Mandatory Goizper Clutch-Brake Upgrade

for Stolle B6 / B7 Standun Bodymakers

Stolle
Standun Bodymaker
Technical Update 1510-1
Rev. 2

Figure 1: Torqued screws - Visual verification and placement of screws. Note the yellow paint markers visually verifying the screws are torqued and have not come loose.

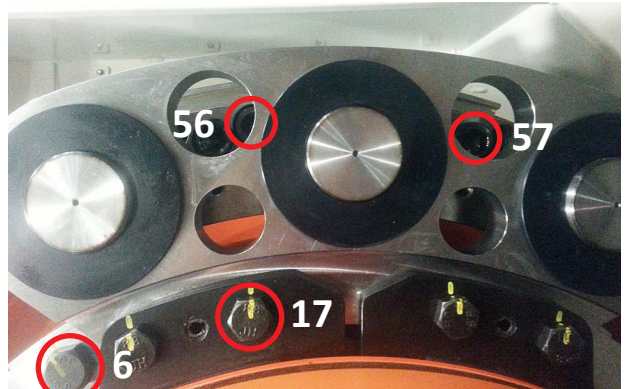
Secondly, Stolle Machinery advises visual and physical verification of all bolts on the assembly of the clutch-brake friction plates and engagement pins. Figure 1 on the right shows all the properly torqued screws and their locations.

Bill of Materials Item #6 from Goizper must be torqued using Loctite 243 (or equivalent) must be applied to the hex head screws and verified for the correct torque of 410 N-m (300 ft-lb).

Bill of Materials Item #17 must be torqued using Loctite 243 (or equivalent) must be applied to the hex head screws and verified for the correct torque of 210 N-m (155 ft-lb).

Bill of Materials Item #56 must be torqued using Loctite 270 (or equivalent) must be applied to the socket head screws and verified for the correct torque of 410 N-m (300 ft-lb).

Bill of Materials Item #57 must be torqued using Loctite 270 (or equivalent) must be applied to the socket head screws and verified for the correct torque of 410 N-m (300 ft-lb).

Figure 2: Front view of the flywheel and clutch assembly with screw locations

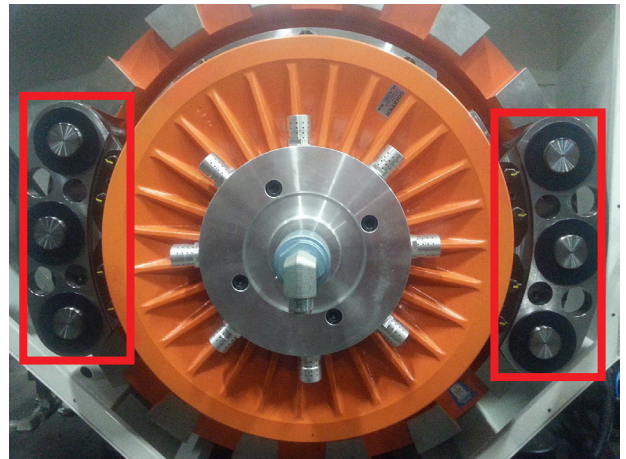
A complete hardware replacement is required for any and all screws that have been loosened or removed. Do not re-use hardware for risk of failure and loss of torque hold.
